**PLANNING APPROVAL &  
SUBDIVISION STAFF REPORT**

**Date: August 18, 2022**

One Mile D.S. Substation Subdivision

Subdivision Approval to create one (1) legal lot of record from several legal lots of record and metes-and-bounds parcels, and Planning Approval to allow an electrical substation in an R-2, Two-Family Residential District.

# DETAIL SITE PLAN

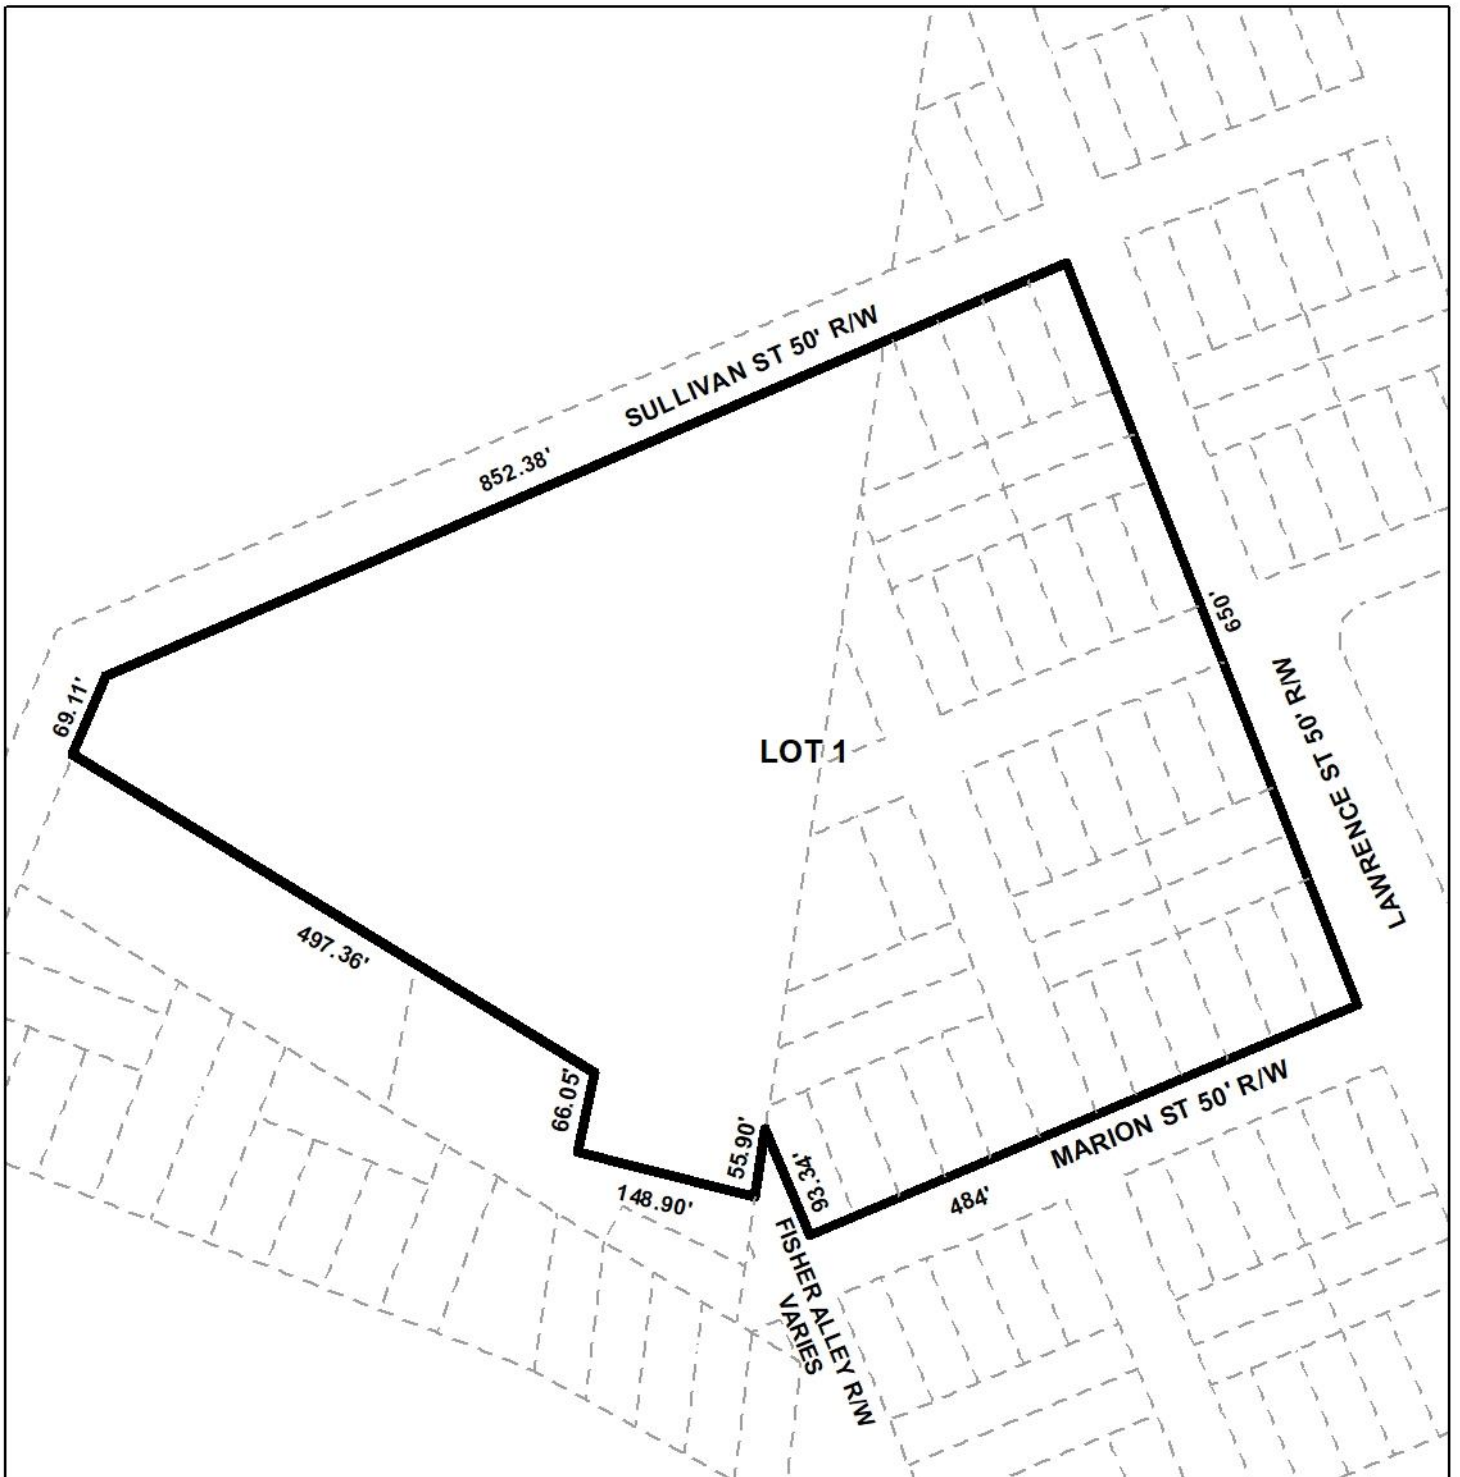
Regarding Planning Approval, the site plan illustrates an electric distribution substation is proposed to be developed along the South property line of the proposed lot. The substation is meant to replace an older substation located  $\frac{1}{4}\pm$  of a mile from the subject site. Two (2) driveways will provide access to the substation, as well as access to what appears to be either a detention or retention pond. It is unclear if the driveways and drive aisles will be paved, although the paving of driveways in R-2 zoning districts is not required.

A fence is proposed on the site per the application, the details of which are not illustrated on the site plan. As such, any fence placed on the property should meet the requirements of Section 64-4.D.6. of the Zoning Ordinance regarding height and setback limitations. Electrified fences must be approved by the Director of the Planning and Zoning Department, and it should be noted that barbed wire is not a permitted material in the R-2 zoning district without approval of a variance from the Board of Zoning Adjustment.

Any gates that limit access to the site are required to be set back from the public right-of-way a minimum of 60 feet so as to allow adequate vehicle queuing; however, gates equipped with automated access, or left open during business hours, are exempt from this requirement. Considering the site will most likely only be accessed by Alabama Power Company employees, presumably for maintenance and repairs, the queuing requirement for any gate may be unnecessary if such a gate or gates is or are not automatic. Waiving the queuing requirement may also be appropriate as the gates will prevent anyone from entering the site, which is potentially dangerous given the proposed use.

No sidewalk is illustrated along any street frontage. The Complete Streets Policy, adopted by City Council in May 2011, requires sidewalks to be built along any street a new development has frontage. As such, the site plan should be revised to illustrate compliant sidewalks; or, the applicant may submit an application for a Sidewalk Waiver for the Planning Commission to review.

- 1) Resolve the issues associated with the Subdivision request;
- 2) Revise the site plan to identify the location of the proposed fence and any associated gates; and,
- 3) Revise the site plan to illustrate sidewalks along all improved street frontages, or submit an application for Sidewalk Waiver review.
